86100C-02

S E R V I C E N O T E

86100C Infiniium DCA-J Wide Bandwidth Oscilloscope

New stainless steel anchor for 86100C front frame.

Figure 1 - Location of Anchor

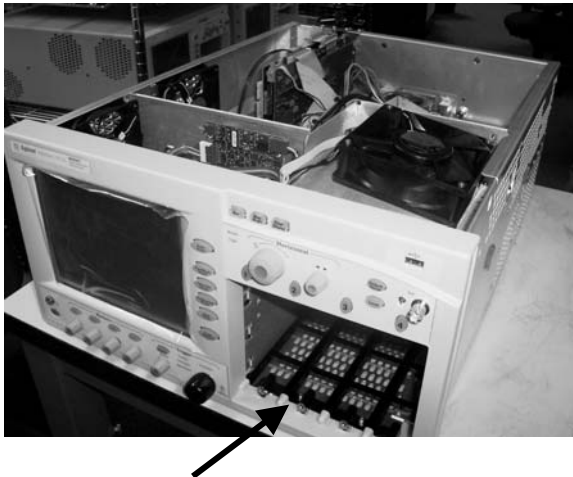
Each DCA Module is fitted with two thumb-screws that secure the module into the DCA Mainframe anchor (see Figure 1). This ensures good connections between the module rear panel and mainframe.

The original mainframe anchor (P/N 86100-20044) was made of two materials: steel (body) and aluminum (threaded insert for the module screws). It was found that some of the aluminum heli-coil inserts would separate from the body of the anchor if the DCA Module was removed prior to fully disengaging the thumb-screws, or that the DCA Module thumb-screws would not engage enough threads on the heli-coil.

The anchor material has been changed to all stainless steel, and the threaded surface was brought forward by 3mm to ensure proper module thumb-screw engagement.

The module anchor should be replaced if any of the anchor heli-coils are missing, or if it is difficult to engage the module thumb-screws into the anchor.
